EMISSION RECALL BULLETIN

Subject: **Emission Recall D19R3**
GHG17 DD Platform Model Years 2019 Software
Reprogramming

Figure 1 – DiagnosticLink® Identification Screen

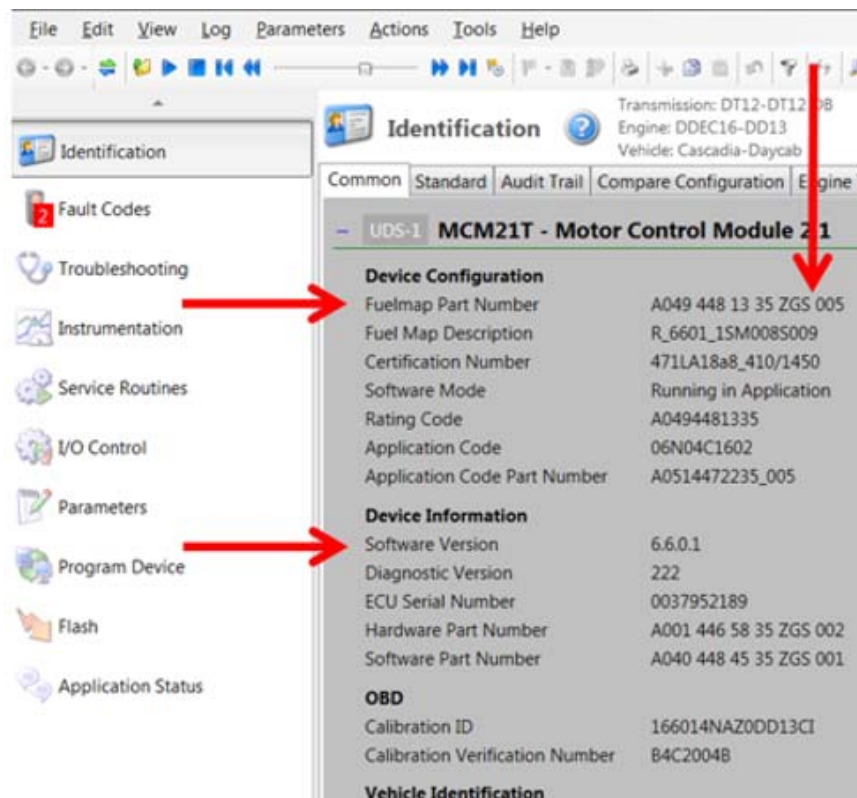
5. On the Identification screen, check the current MCM and ACM software and fuel map level. Listed below are the **MINIMUM** levels required. See Figure 1 for an example of the Identification screen for the MCM and Figure 2 for an example of the Identification screen for the ACM.
 - a. MCM **software 6.7.0.2** and fuel map version **ZGS 002**
 - b. ACM **software 7.59.2.0** and fuel map version **ZGS 002**
 - c. For non – New Cascadia, CPC **software R42_00_000A**
 - i. Note: For Classic Cascadia with DT12 and ICU3, CPC **software X42_01_000A**
 - d. For New Cascadia vehicles, CPC **software 31.23.00**
 - e. For DT12 equipped vehicles, TCM **software NAMT150700** (if equipped with the Detroit™ DT12™ transmission)

6. Is the software level for the MCM, ACM, CPC, and if applicable the TCM, less than, equal to, or higher than the minimum software levels listed in step 5? All modules must meet the **MINIMUM** requirements. For example, in Figure 1, MCM software 6.6.0.1 and Figure 2, ACM software 7.58.2.0 are both less than the minimum levels of 6.7.0.2 and 7.59.2.0, and thus would require programming, regardless of fuel map ZGS version.

- a. If less than the minimum software levels, proceed to step 7.
 - b. If greater than the minimum software levels, no programming is necessary. Proceed to step 11.
